# APPENDIX K: PHASE 2 DRAFT EIS COMMENTS & RESPONSES

Reproduced Letters and Cross-referenced Responses follow this Index ([hyperlinked](#)).

OO1-F-7

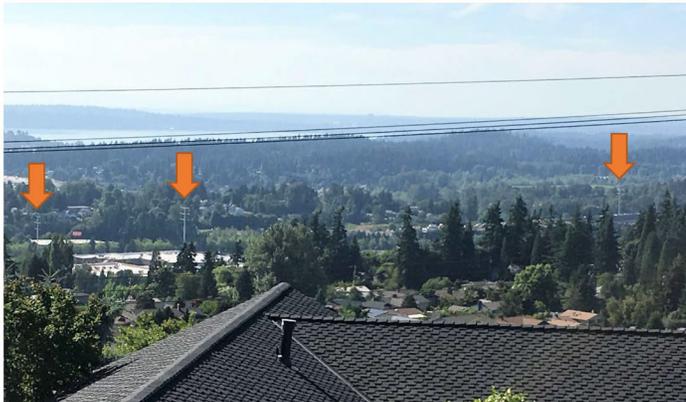
Power poles are also visible at distances greater than ¼ mile. Here is a photo taken near the Somerset Rec Club. The visible man-made structures include some roofs, nearby transmission lines, and the Seattle City Light power poles. The latter are noticeable against the background even 1 mile away:

It is true that the project could be seen at distances greater than a quarter mile. Given that the proposed location would be in an area that is generally well-vegetated, developed, and has varying topography, the views where this project would still be noticeable are few. This was confirmed by desktop analysis, site visits, and GIS analysis. For example, one simulation (see Figure 4.2-8 in the Final EIS) is taken from just beyond a quarter mile away, and visibility of the line is limited (not producing significant aesthetic impacts). A quarter mile was selected because that is where it is most likely to have significant adverse impacts. In the screenshots provided in the comment, the line is visible, but not a defining feature. It blends with the surrounding development. Furthermore, the project would not create new "notches" in the treeline as shown, because it would use an existing corridor. The mere visibility of the project does not constitute a significant impact. Simulations from Downtown Bellevue were not created because it is outside the quarter-mile study area; no specific location was identified in the comment where impacts could be significant. There would be enough visual separation between the project and Downtown Bellevue that the project would not result in significant adverse impacts.

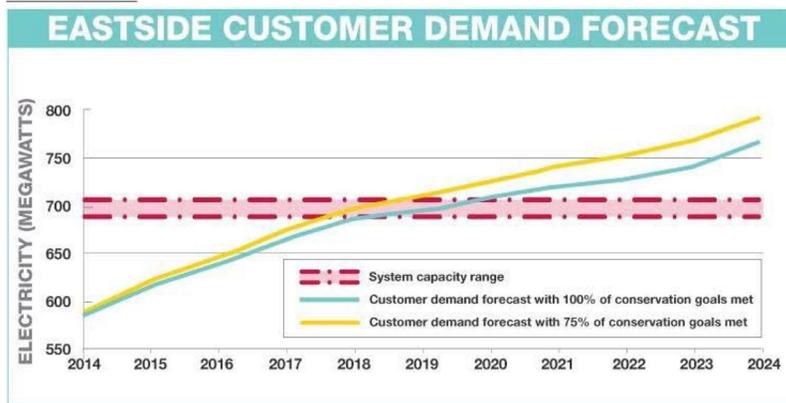
The EIS says Energize Eastside is needed "to address a projected deficiency in transmission capacity resulting from growth in electrical demand which could affect the future reliability of electrical service for the Eastside." However, the EIS does not provide any numbers or charts to help the public understand exactly what the need is. In the past, PSE showed graphs like this one which appeared on the Energize Eastside website:

I177-A-10 This graph has now disappeared from PSE's website. Although we don't know exactly why this graph has become so shy, we wonder if the actual values for 2014-2016 are decreasing (the numbers in this graph were forecasts). Is PSE trying to avoid embarrassing questions about the need for the project?

**Figure 1:** Washington State Seismic Hazard Map, Seattle Fault, M7.2 (Magnitude 7.2) Scenario.

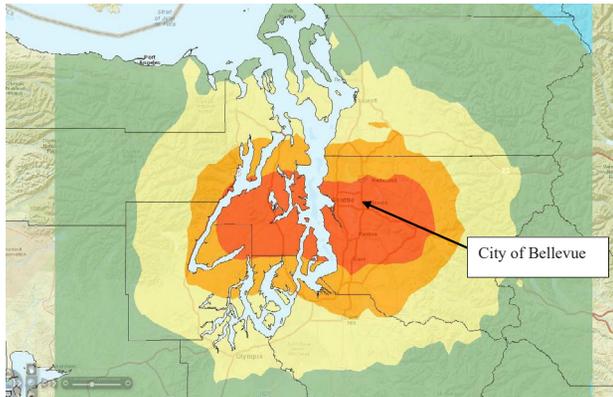
The risk of a large earthquake in the Eastside and Puget Sound Region is well documented (see Phase 1 Draft EIS, Chapter 3 and the above reference list). Figure 1 shows the estimated hazard zone from a magnitude 7.2 Earthquake.

Figure 2: USGS Earthquake Hazards, 2006

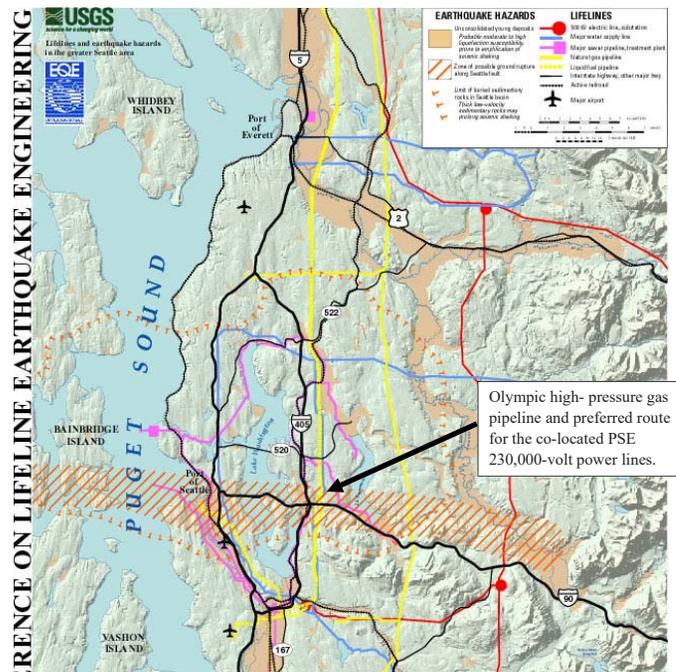
The 2006 United States Geological Survey (USGS) map (Figure 2) shows the Olympic high-pressure pipeline route (shown using the yellow dashed line immediately east of 405) which, under the preferred alternative, would be co-located with the PSE 230,000-volt powerlines. This pipeline and 230,000-volt transmission line cross the zone of potential ground rupture (shown in orange hash tags).

**Figure 3 Annual minimum ambient temperature day history**

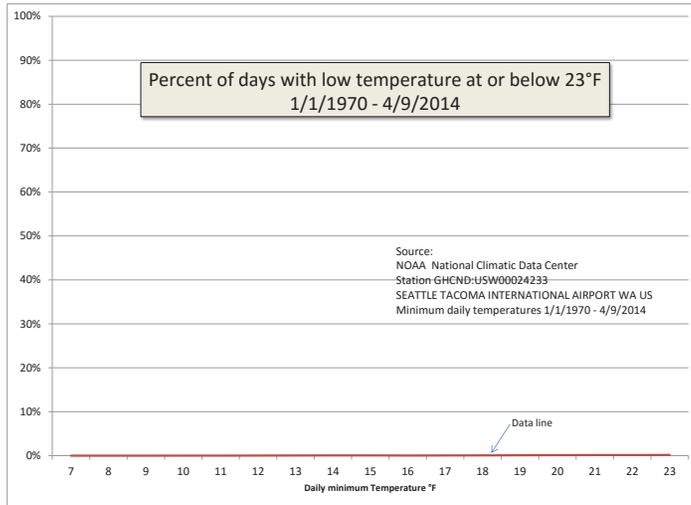
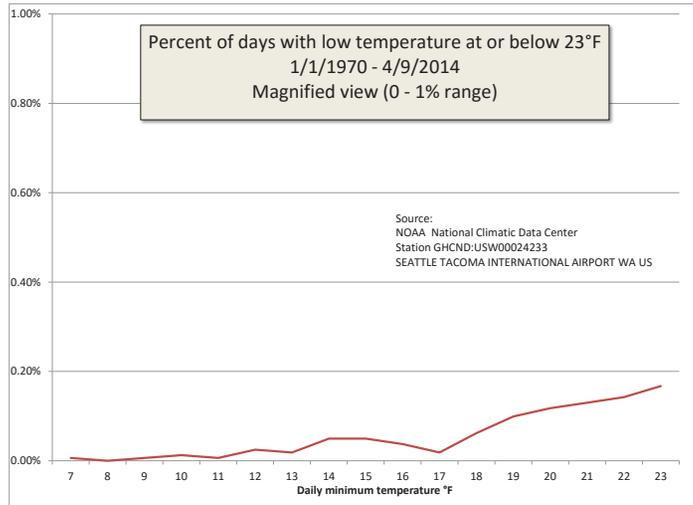
The NOAA National Climatic Data Center has a database of daily minimum temperatures for Station GHCND:USW00024233 SEATTLE TACOMA INTERNATIONAL AIRPORT WA US. Figure 3 is a summary of 16170 daily minimum temperature measurements in a period between January 1, 1970 and April 9, 2014. The horizontal scale is the daily minimum temperature in one-degree Fahrenheit increments from the lowest measured value in the period (7°F) to 23°F. The vertical scale ranges from 0% to 100% and is the percentage of the period in which each minimum temperature was recorded.

Since the occurrences of 23°F and lower temperatures days are extremely infrequent an expanded view of the bottom 1% is provided in Figure 4.

Figure 5 PSE's solution versus stated need in perspective

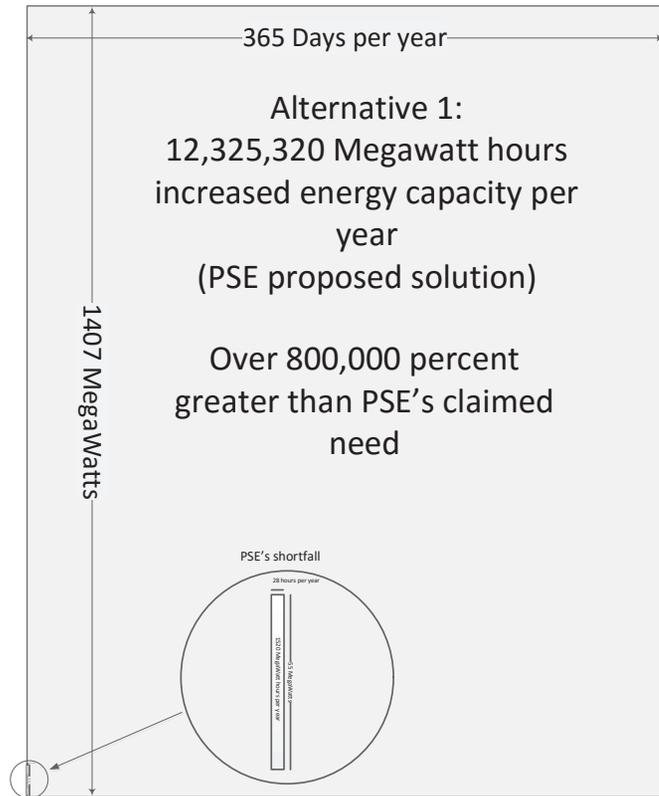
Figure 5 shows the relative scale of PSE's proposed project versus PSE's statement of need during the CAG process. To be clear, the percent increase in capacity vs need as stated above is over 800,000 percent. An increase of this magnitude will never ever be needed in the PSE customer base area.

I1122-A -58 See response to comment OO4-F-2.

Figure 6

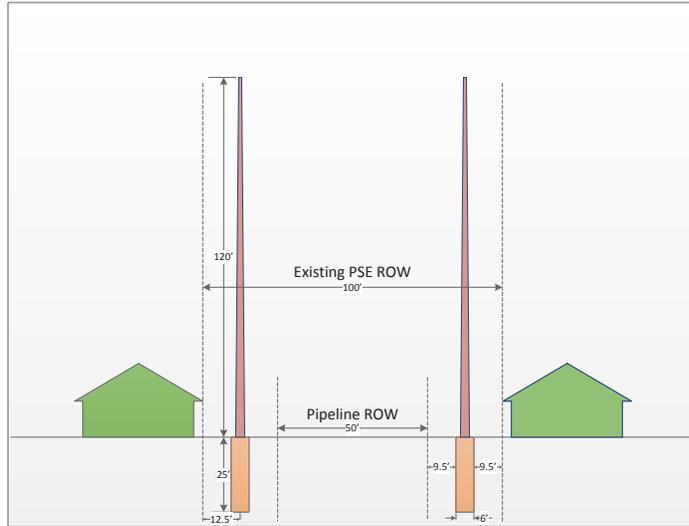
Figure 6 shows the nominal location of 120 foot tall monopole towers on 6 foot diameter footings to support the proposed 230kV lines. The footings must be placed in undisturbed soil to be able to withstand lateral forces on the monopole. A minimum margin of undisturbed soil around the footing is required and must be within the PSE power line ROW. As can be seen, the footings can only be located within the outer 25 foot margins of the 100 foot wide PSE power line ROW without directly violating the hazardous liquid pipeline ROW. The edge of the footing is potentially within 9.5 feet of existing and future residential structures given the current 100 foot wide easement. This is far too narrow.

Figure 7

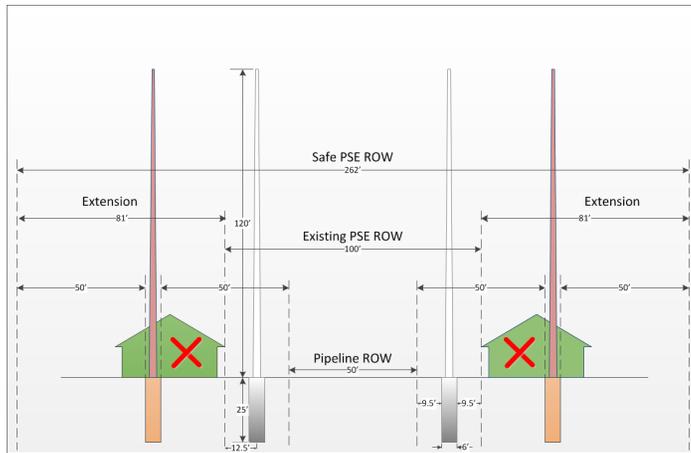
Figure 7 shows the proper extent of a 230kV power line ROW adjacent to a pipeline consistent with BPA standards. Although not as rigorous as other U.S electrical power industry standards it does present a moderate safety solution. As can be seen, the existing ROW has insufficient width to accommodate the proposed 230kV power line. Clearly, the application of common sense modern standards precludes the routing of the 230kV power line through route 'M' within the existing corridor.
